**HITACHI****GE Hitachi Nuclear Energy
Global Laser Enrichment, LLC****Albert Kennedy**GLE Environmental Health and Safety
Manager3901 Castle Hayne Road
P.O. Box 780
Wilmington, NC 28402
USAT 910-819-1925
M 910-200-9805
Alberte.Kennedy@ge.comLetter number MFN-09-690
November 5, 2009Global Laser Enrichment
Docket Number 70-7016Document Control Desk
ATTN: Andrea Kock, Chief
Environmental Review Branch
Division of Waste Management and Environmental Protection
Office of Federal and State Materials and Environmental Management Programs
U.S. Nuclear Regulatory Commission
Washington, D.C. 20555-0001SUBJECT: GE-HITACHI GLOBAL LASER ENRICHMENT RESPONSE TO REQUEST FOR
ADDITIONAL INFORMATION RELATED TO NRC REVIEW OF GLE
ENVIRONMENTAL REPORT

Enclosure 1

GLE Response to Environmental RAIs

Figure 4.5(E): Age and Condition of Biotic Communities Dominated by Pine

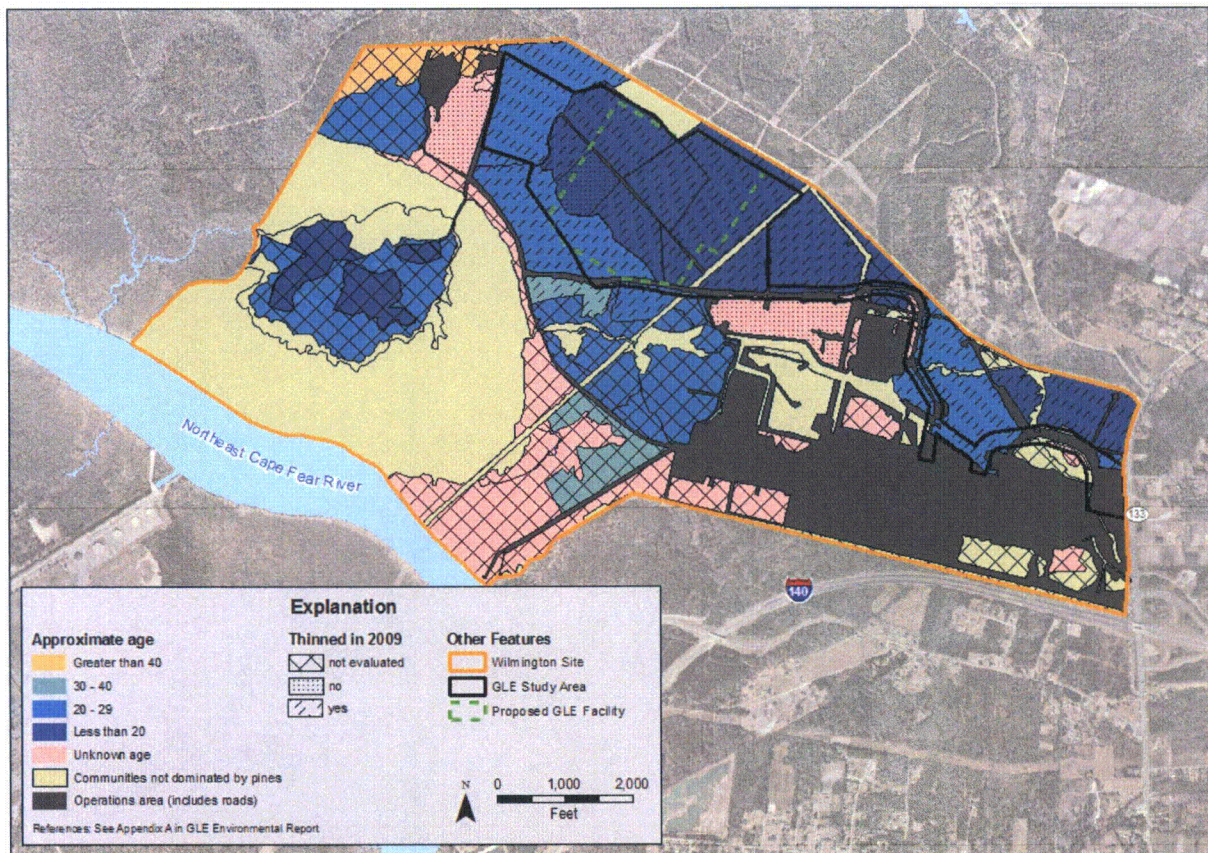
- E. Provide the most recent dates and areas where logging has occurred in the area proposed for the GLE facility. Also, provide whatever similar summary data is available for logging on the Wilmington site since 1980 (approximately). This information is needed to support conclusions about the suitability of the site for red-cockaded woodpecker habitat.

Figure 4.5(E) illustrates the age of the forest communities based on the 2009 GE Forest Management Plan; however, this scale is not at a fine enough resolution to identify areas that were planted versus naturally regenerated. The area within or adjacent to the GLE Study Area was observed in October 2009 to verify which areas had received thinning treatments. In addition to being thinned, some areas received additional reduction of sub-canopy vegetation within the rows.

Figure 4.5(F). Planned Projects on the Wilmington Site.

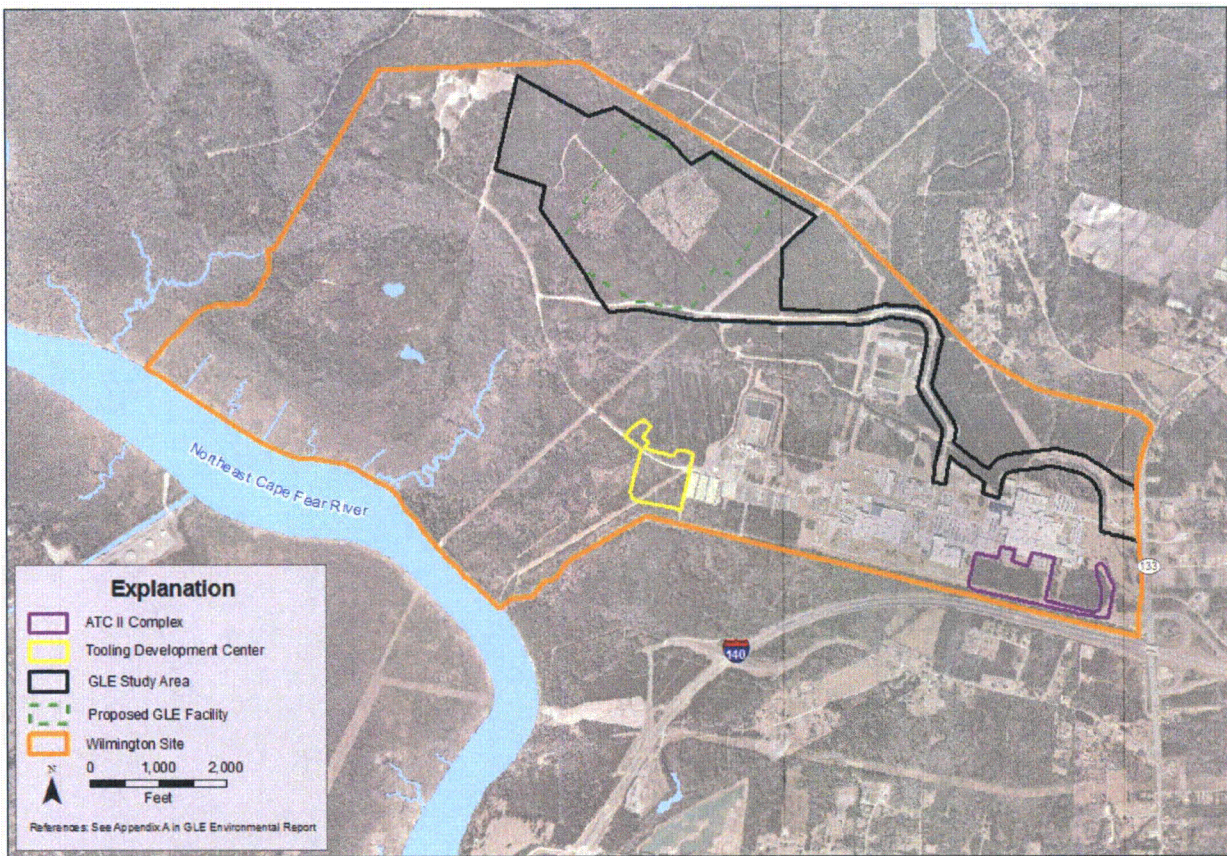
- F. Provide a figure similar to ER Figure 1-2 that shows the “30-acre” area outlines for the proposed ATC II complex and the Tooling and Development Center. This information is needed for the cumulative impacts analysis.

Figure 4.5(F) illustrates the location of the proposed ATC II Complex and the Tooling Development Center on the Wilmington Site. The ATC II complex in the southeastern portion of the Eastern Site Sector near the South Gate has impacted approximately 20.66 acres (8.36 ha) consisting of 11.30 ac (4.57 ha) of Pine Forest and less than 0.01 acres (0.01 ha) Pine-Hardwood Forest.

The Tooling and Development Center would impact approximately 16.31 acres (6.60 ha), consisting of 0.28 ac (0.13 ha) of Pine Forest, 7.27 ac (2.94 ha) of Pine-Hardwood Forest, and 6.45 ac (2.61 ha) of Pine Plantation habitat in the western portion of the Eastern Site Sector. The cumulative effect from both of these projects would be the loss of approximately 24.3 acres (9.8 ha) of habitat in conjunction with the loss of approximately 177 acres (72 ha) of habitat from the Proposed Action. Total loss of available habitat would be approximately 202 acres (82 ha), comprising 16% of the forest habitat currently on the Wilmington Site.
